PLANNING COMMISSION REPORT
Regular Agenda – Public Hearing Item

PC Staff Report
11/17/2014

ITEM NO. 1 CONDITIONAL USE PERMIT FOR VERIZON WIRELESS; 1287 E 1200 RD (SLD)

CUP-14-00298: Consider a Conditional Use Permit for a new 190' Verizon Wireless communications tower located north of the Westar Substation at 1287 E 1200 Rd. Submitted by PAMCORP LLC for Verizon Wireless LLC on behalf of The Kansas District of the Wesleyan Church Inc, property owner of record.

LSE-2

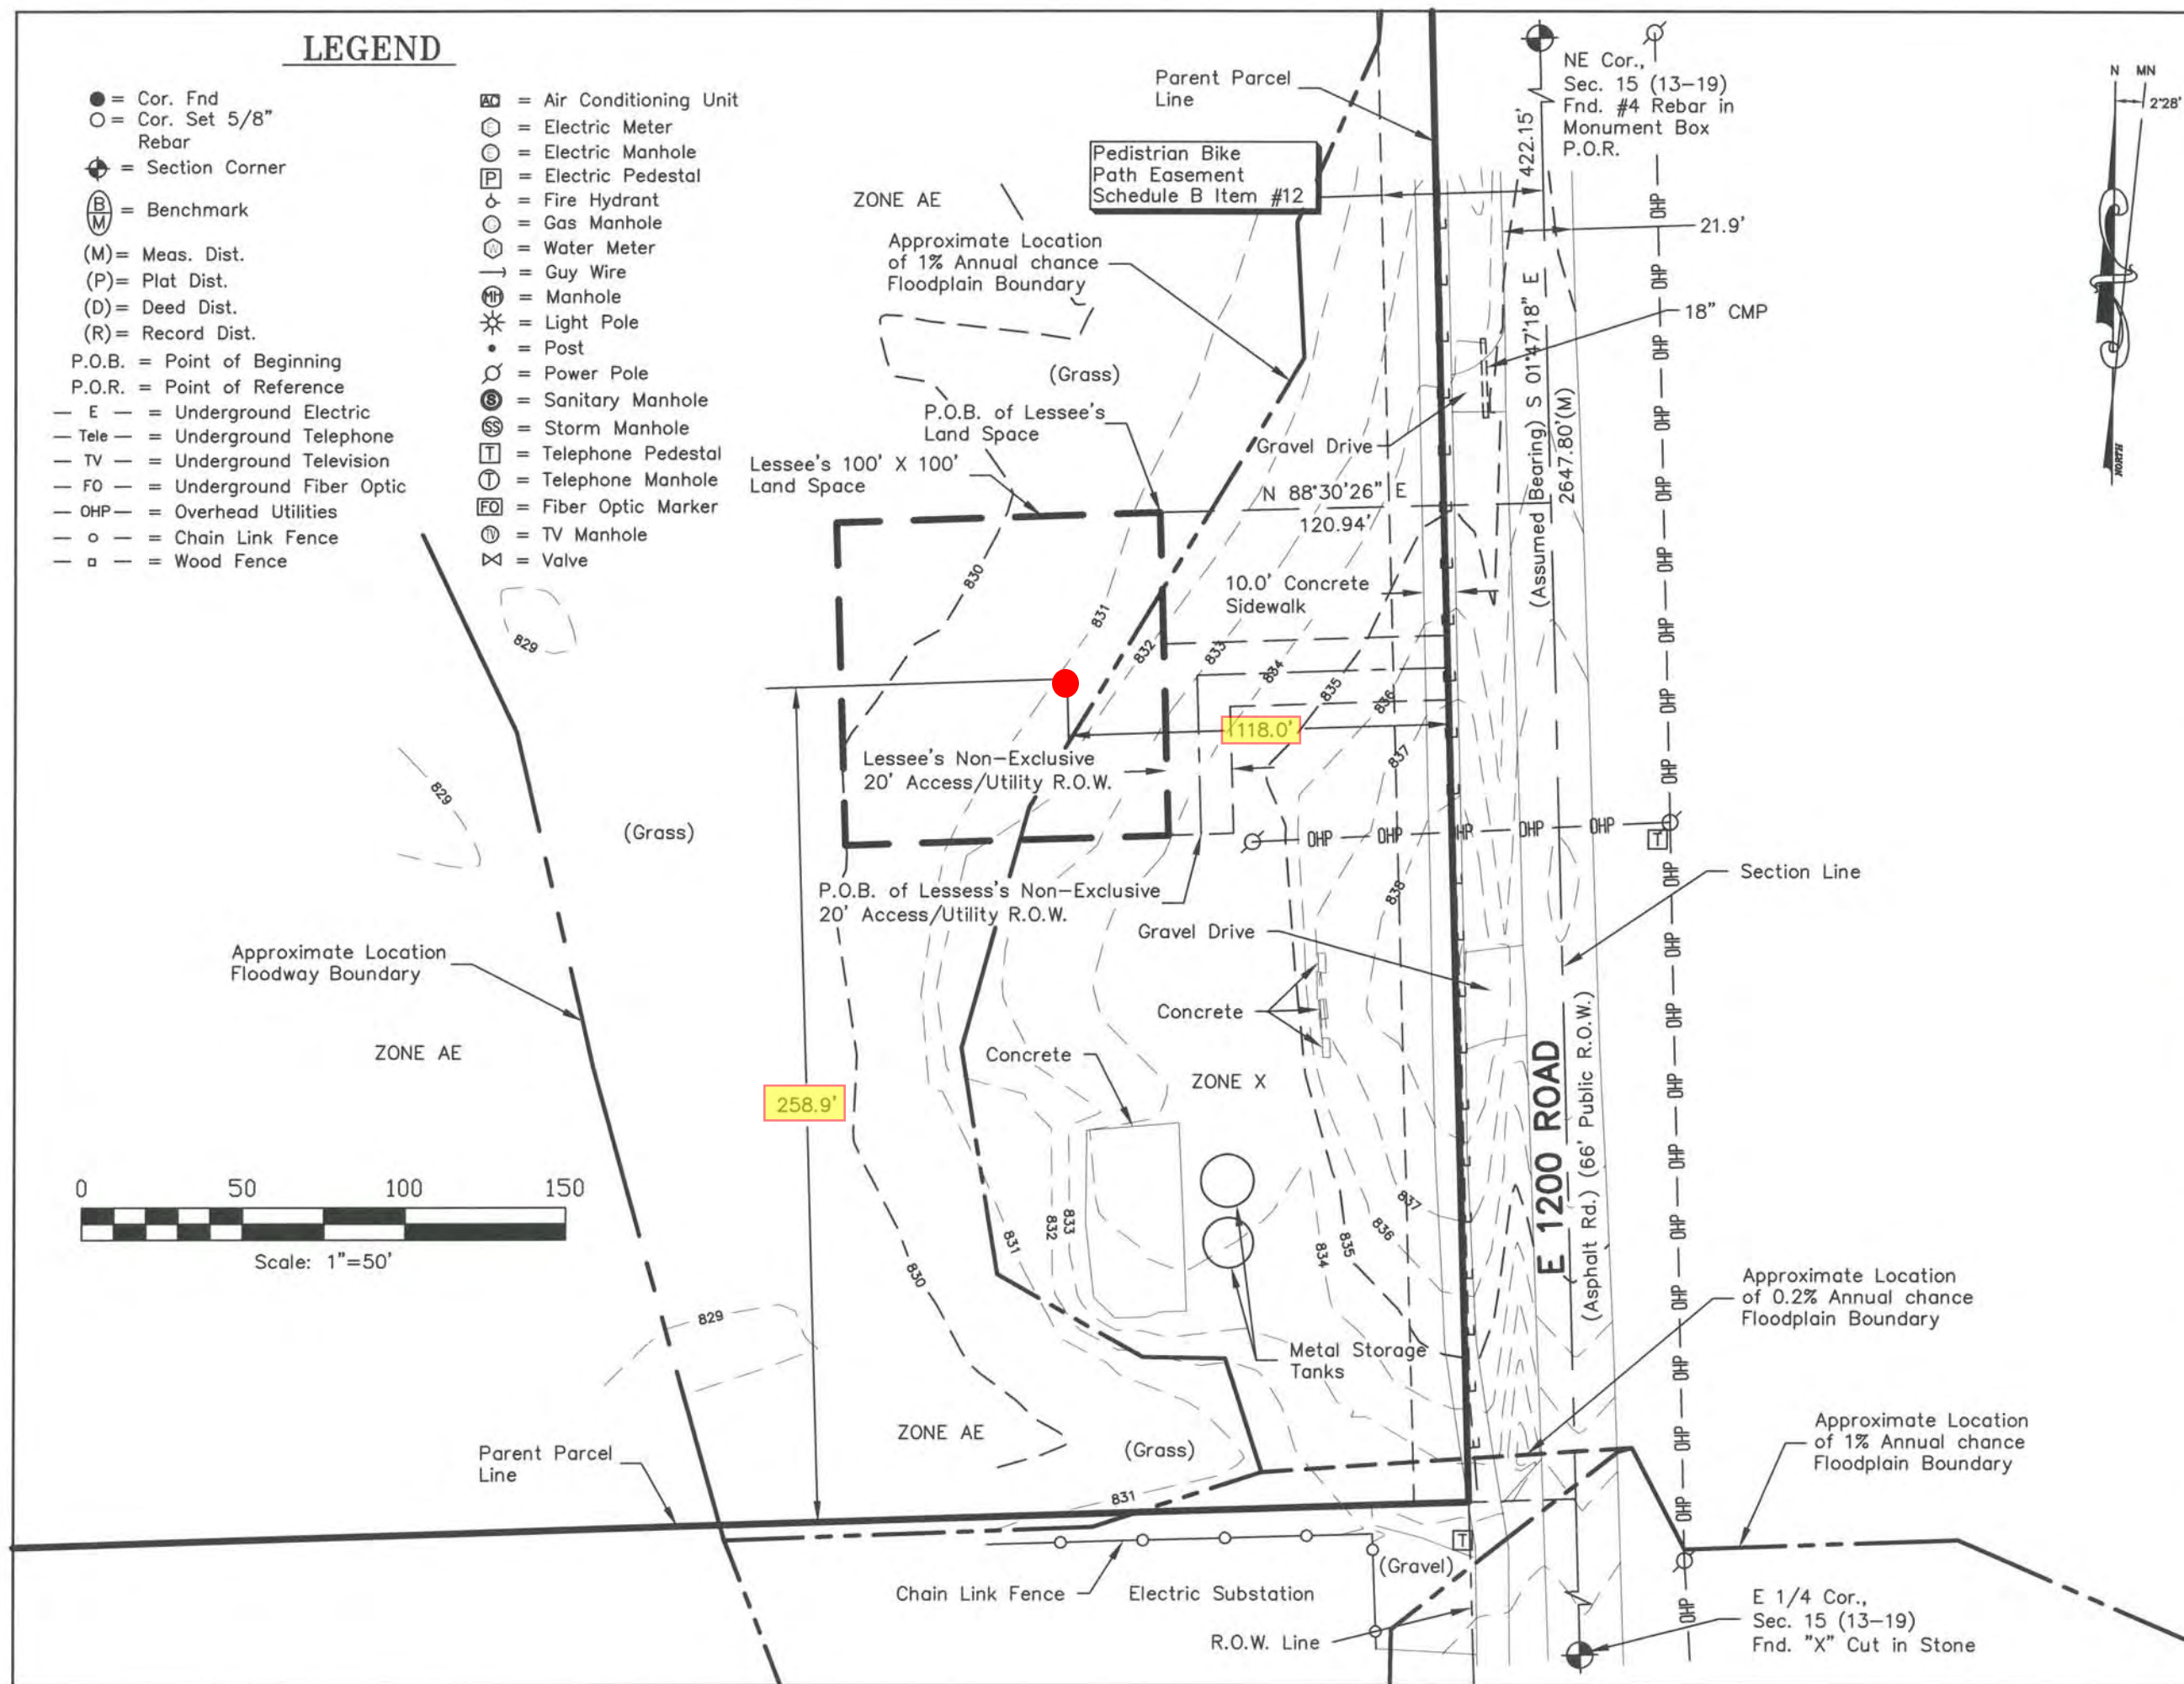
The setback of the communication tower is required per section 20-319-4.31(d) to be at least equal to the height of the tower to the nearest property line measured from the center of the tower. The east property line is the nearest property line to the proposed improvements. The tower setback may be reduced when documentation from a registered engineer is submitted certifying the “fall zone” of the tower in the event of a failure. Evaluation of the required structural documentation will continue to be reviewed with the submission of a building permit to the County Zoning and Codes Office. The proposed setback is shown to be 118' from the east property line to the center of the tower.

The tower and ground equipment will be located in a 100' by 100' enclosure area located approximately 90' from the east property line. The initial enclosure area will be 50' by 50' to accommodate expansion of the base station as additionally carriers co-locate on the tower.

The proposed equipment shelter is located approximately 100' from the east property line. The site plan shows pad sites within the enclosure to accommodate future carriers located on the north and west sides of the tower. The initial 50' by 50' fenced enclosure would need to be expanded to accommodate future co-location applications.

L-1

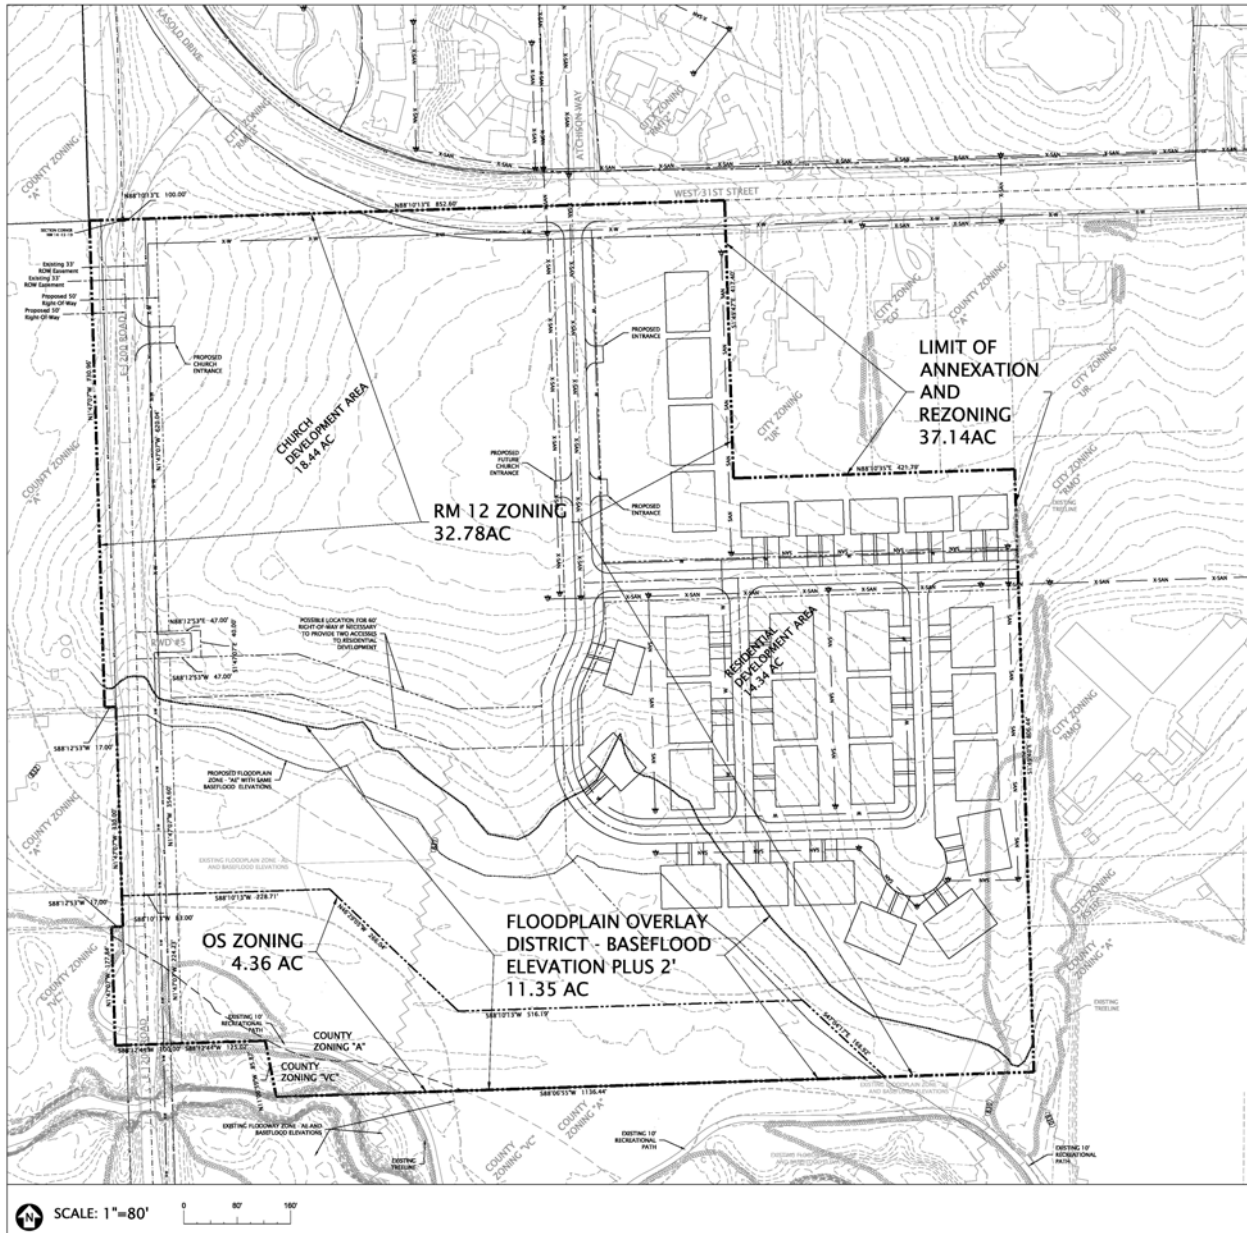
- 1) Provision of a revised site plan to include the following changes:
 - a) Revise the landscape plan to show five (5) street trees along E 1200 Road/Kasold Drive located 8' from west side of pedestrian pathway.
 - b) Revise the site plan to show a city approved access driveway apron and a paved access drive from the apron to 6' west of the recreation path.

The site plan as submitted includes screening vegetation around three sides of the proposed enclosure. This site will not be irrigated and will not be staffed. The survival of this type of vegetative plan is usually unsuccessful especially in a rural application. An alternative to the proposed landscaping will be to provide street trees along E 1200 Road/Kasold Drive as would be required in a comparable City application. A development with 100' of frontage, in the City, would be required to provide three street trees. Staff recommends additional trees as an alternative to the perimeter screening proposed.
